# Report on “public consultation of new aFRR design”

Public Consultation held between 03/09/2018 – 30/09/2018

31/10/2018

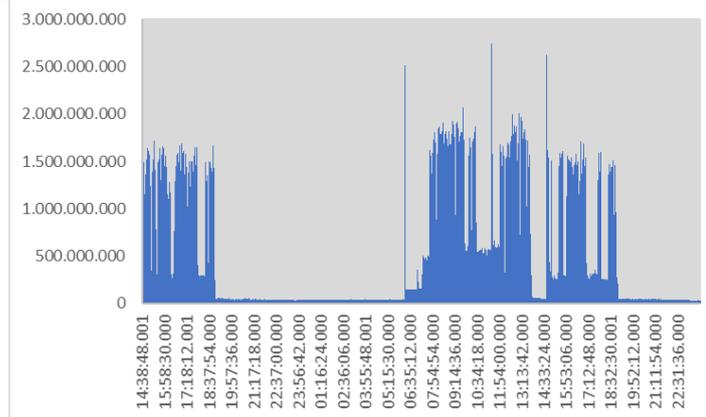
Next Kraftwerke	As Elia considers an activation following the set-point with +/- 7.5 % as compliant, we think that an overdelivery of 7.5% should not be considered an overdelivery yet. Any volume exceeding the 7.5% should however be considered overdelivery and can indeed be corrected as suggested in Annex 2 – Case Study.
-----------------	--

Elia explains there is a clear difference between the rules for activation controls and the settlement in the context of ToE, as is also the case in the mFRR market. Even when an overdelivery occurs within a 7,5% limit, an impact is caused in the portfolio of the ARPSource and Supplier and therefore needs to be treated accordingly following the modalities of the ToE-framework.

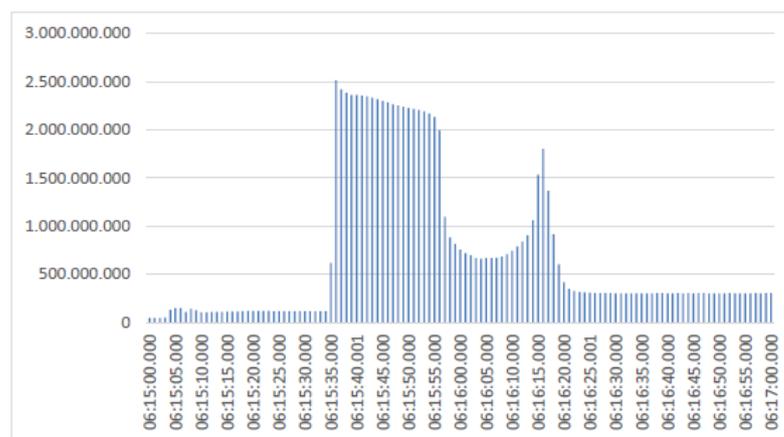
Il est déjà possible de constater sur ce graphique qu'il y a des pointes de consommation importantes qui durent 1 seconde. Si la « photo » 4 secondes est prise à ce moment-là, cela peut entraîner une surévaluation de l'énergie réellement mise en oeuvre.

Si l'on effectue un zoom sur le moment où la charge est lancée, soit à 6h15, nous avons le graphique suivant :

Sur cette période, nous avons calculé l'intégrale de l'énergie consommée, soit 23.701 kWh.

Si nous considérons 3 captures toutes les 4 secondes que nous décalons de 1 seconde (mesure 1 à 6 :15 :00 et puis + 4", mesure 2 à 6 :15 :01 et puis +4" et mesure 3 à 6 :15 :02 et puis +4"), nous pouvons calculer l'énergie sur cette base :

Nous pouvons constater sur ce simple exemple que l'écart du calcul de l'énergie selon le moment où la mesure est prise peut varier de plus de 10%.
